**IN THE MATTER OF THE  
VOLUNTARY REQUEST OF  
ROCKY MOUNTAIN POWER FOR  
THE APPROVAL OF RESOURCE  
DECISION TO REPOWER WIND  
FACILITIES**

)  
) **DOCKET NO. 17-035-39**  
) **DPU Exhibit 2.0 Confidential RESP**  
) **Response Testimony and Exhibits**  
) **Daniel Peaco**  
)  
)  
)

**Response Testimony of**

**Daniel Peaco**

**Figure 1. Implied Market Heat Rate**

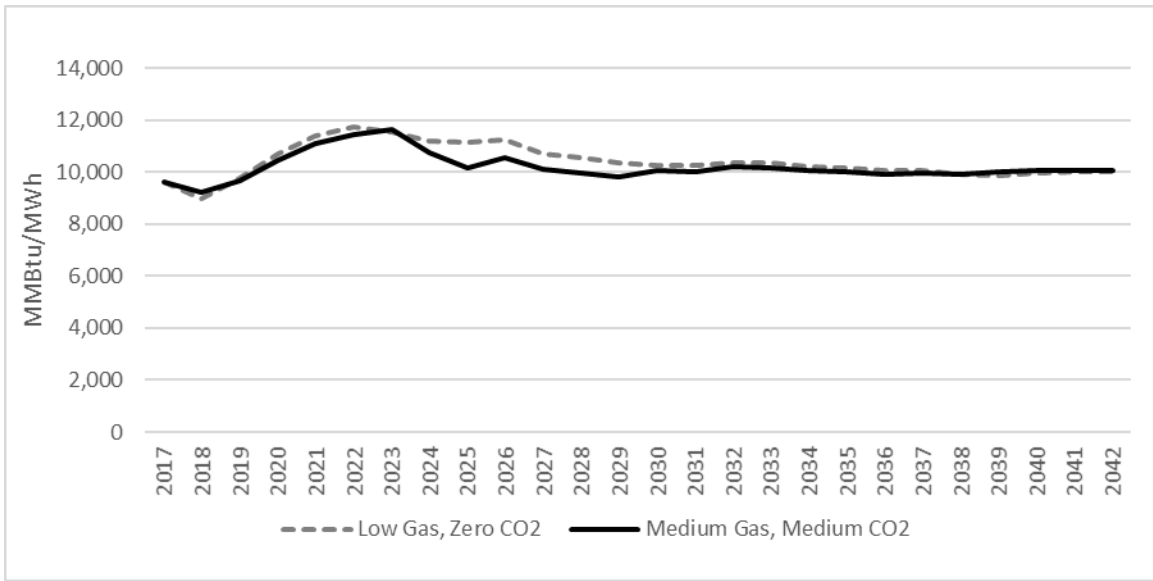
These results show that the Company's market price assumptions yield an unreasonably high MHR. For example, in 2022, the MHR in the Medium Gas, Medium CO<sub>2</sub> scenario is 11,445 MMBtu/MWh. This result means that, on an annual average, a natural gas fired unit with an 11,445 heat rate would be the marginal unit in the market. This is highly unlikely, as an average new combined cycle unit should have a heat rate of less than 7,500 and an average peaking plant should have a heat rate near 10,000. Therefore, a MHR of 11,455 MMBtu/MWh is significantly higher than the cost to produce power from natural gas-fired plants, demonstrating that the Company's Palo Verde prices are too high and not consistent with its natural gas price forecasts. A more typical benchmark annual MHR would be between 8,000 and 9,000, not the much higher value contained in the forecast that the Company has used.
